**TOWN OF FAIRFAX  
STAFF REPORT  
Department of Planning and Building Services**

**TO:** Fairfax Planning Commission  
**DATE:** April 21, 2016  
**FROM:** Jim Moore, Director of Planning and Building Services  
Linda Neal, Principal Planner  
**LOCATION:** 288 Bolinas Road; Assessor's Parcel No. 002-022-19  
**ZONING:** Residential Single-family RS 6 Zone  
**PROJECT:** Remodel/Expansion of a Residential Structure  
**ACTION:** Hill Area Residential Development permit, Variances, Excavation permit; Application # 16-13  
**APPLICANT:** Rich Rushton, Architect  
**OWNER:** Justin Morgan  
**CEQA STATUS:** 15301(l)(4), 15303(e) and 15305(a).

**288 BOLINAS ROAD**

**A Resolution Of The Fairfax Planning Commission Approving Application No. 16-13 For A Hill Area Residential Development Permit, Encroachment Permit, Excavation Permit, Design Review Permit And Front Setback Variance For A 50% Remodel Of An Existing Duplex Conversion To A Single-family Residence And To Construct A 2-car Garage At 288 Bolinas Road**

**POST-DEVELOPMENT DRAINAGE MAP**

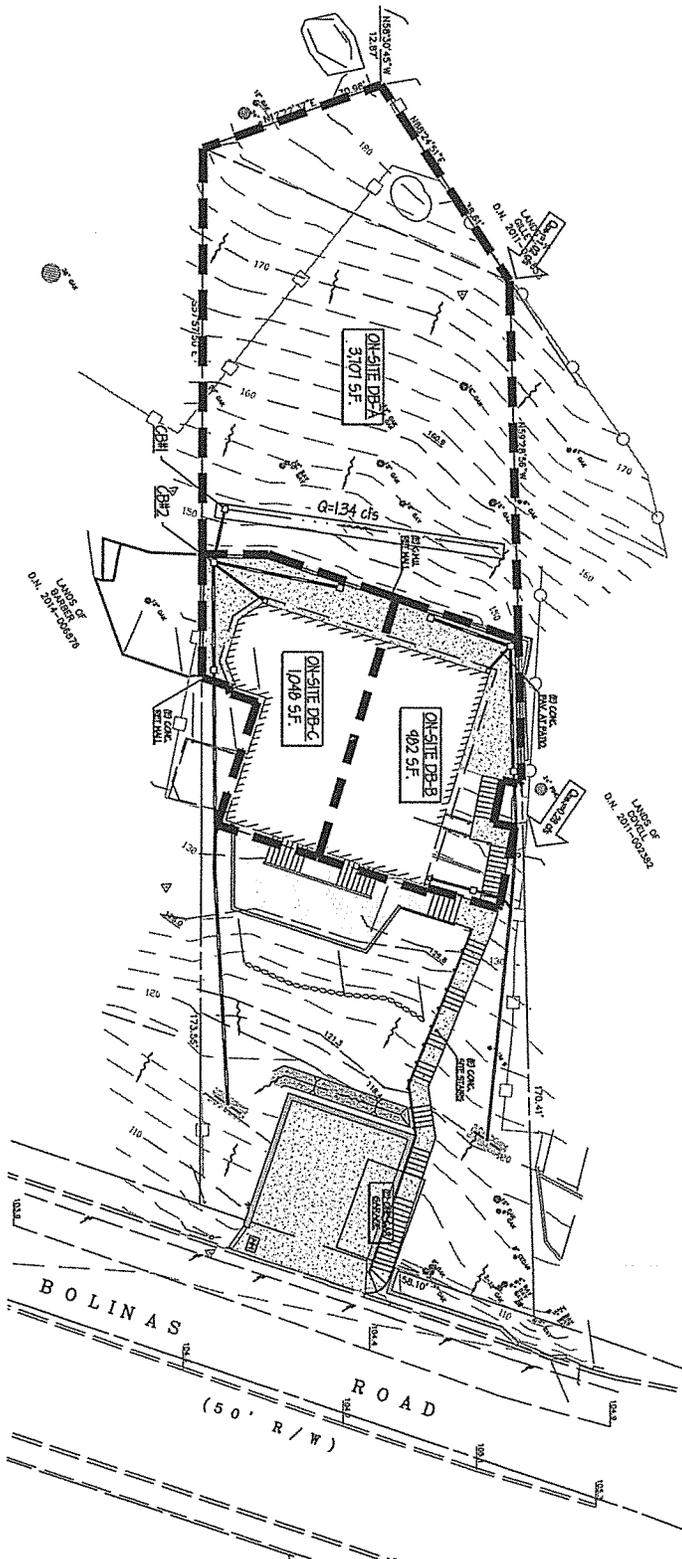
using a method that produces lesser flows produce more troublesome overflows as the design flows get smaller. The drainage flow calculations must be revised and the stormwater conduit systems must be sufficiently sized and shown for this application's submittal so that, as the plans move through reviews, an at least adequate drainage system size is visible. Systems must be sized reasonably. A 4" pipe at the steep slope on this site would appear to carry a one cubic foot per second flow but that flow is unlikely to go into entrances and through bends due to energy losses. Different calculation methods can be used but the resulting design flows must be at least close to or greater than the Caltrans method so that adequate function can be expected.
